Councillors of the East Area Committee

Cambridge Cycling Campaign

Sainsbury's Mill Road 11/0710/FUL

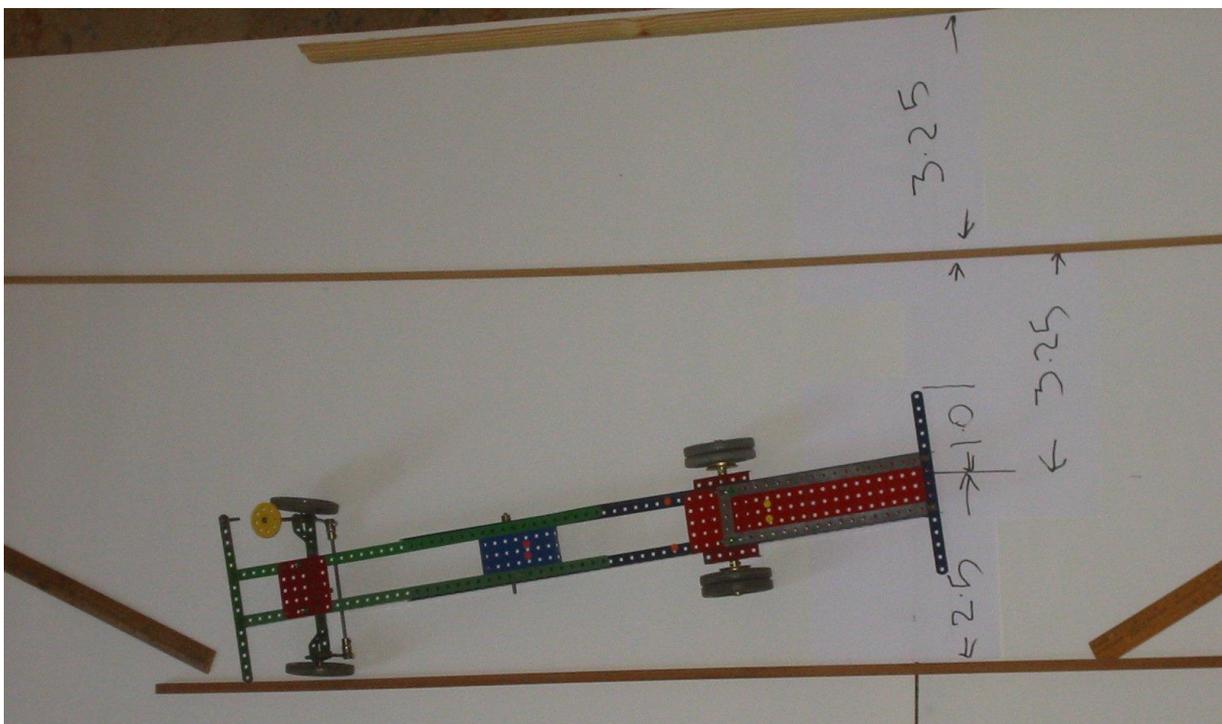
“When a large vehicle enters a bay like this, it is impossible for the rear wheels to get close to the kerb, unless it either reverses in or the front wheels mount the footway by a significant amount, the first of which is dangerous in a busy area such as this, and the second of which is illegal. A quick test suggests that as the front of the vehicle reaches the point where the bay begins to narrow at the end of the 12m section, the rear will still be sticking out over one metre into the highway. This leaves insufficient space for any car to pass in safety, unless it crosses into the lane for opposing traffic. Such an obstruction is extremely difficult for cyclists to negotiate.

The applicant’s tracking diagrams shown do not seem reasonable unless the vehicle has rear steering, which no such vehicles have. The diagram of the vehicle shown does not look to be that of a typical delivery vehicle, as it shows the axle the same distance from the front and the rear. Normally the front axle is only about 1.5 metres from the front, with the rear axle much further in (say 3.0m). This enables a better weight distribution between the single tyred steering axle and the double tyred rear axles which are permitted to carry greater weight.

How were these diagrams produced?

The photo shows that even taking the best line into the bay the rear is still one metre out into the road. The only way I can see to get the rear end tucked in is to have rear wheel steering. I think the photo makes it clear that unless they drive over the footway they can't get the vehicle fully into the bay. The vehicle they draw is not a typical 11m goods vehicle.”

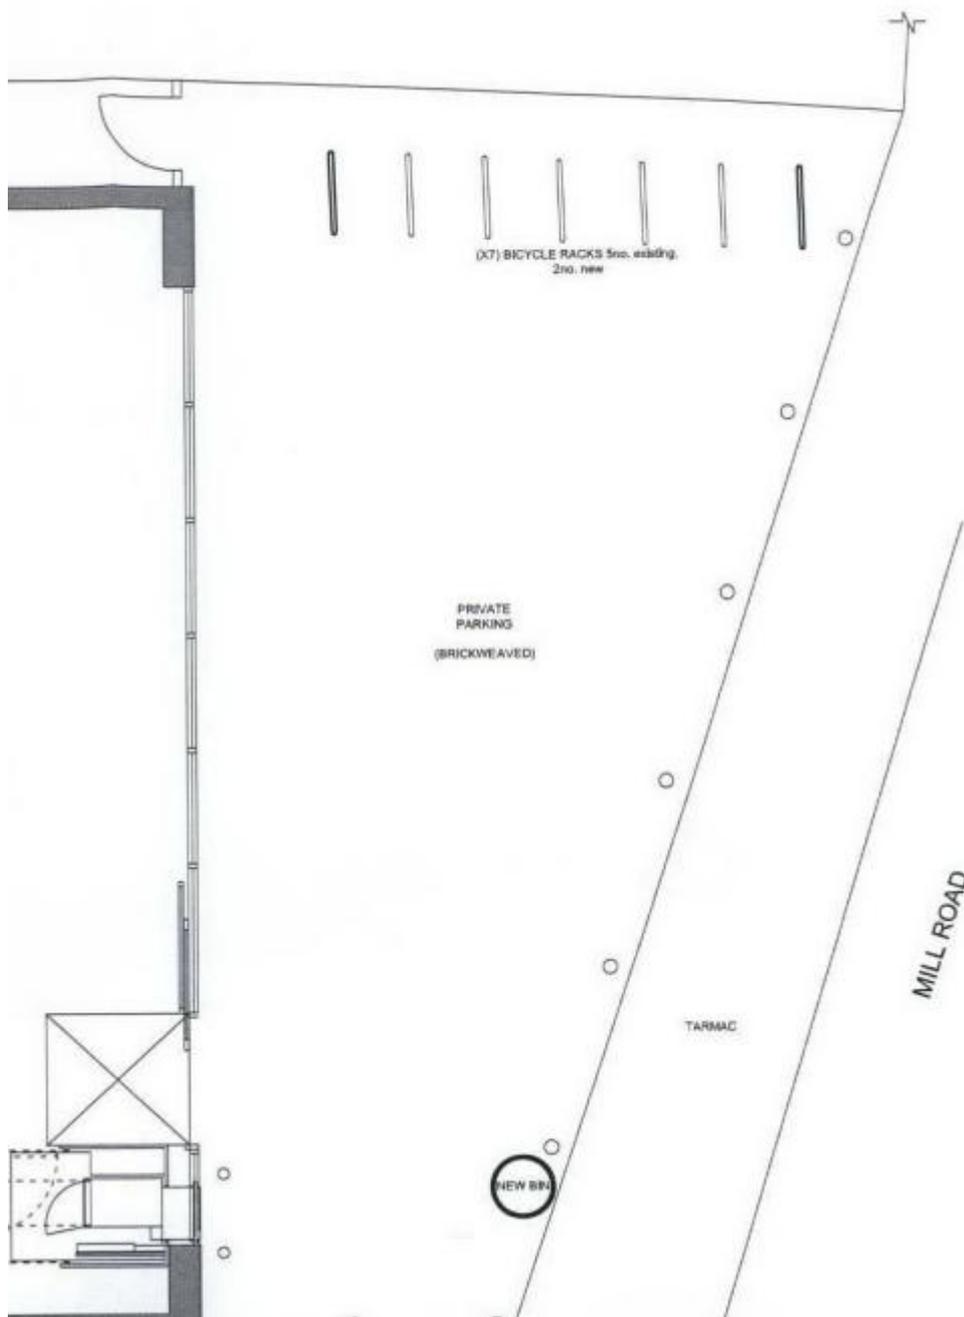
The applicant's drawing shows that there will be additional cycle parking, plus a new bin. There is also a tree. Even if the lorry bay were at the unusable length proposed by the applicant, we do not believe there would be space to create the bay between the tree and the right end of the development. Also, it would seem that the cycle parking would not fit.

Also, the Officer report has worked out the cycle parking wrongly. $383\text{m}^2/25$ is 15.32, i.e. 16 spaces or 8 stands (not 12 spaces and 6 stands). Both the applicant's diagram and the officer's report have too few spaces.
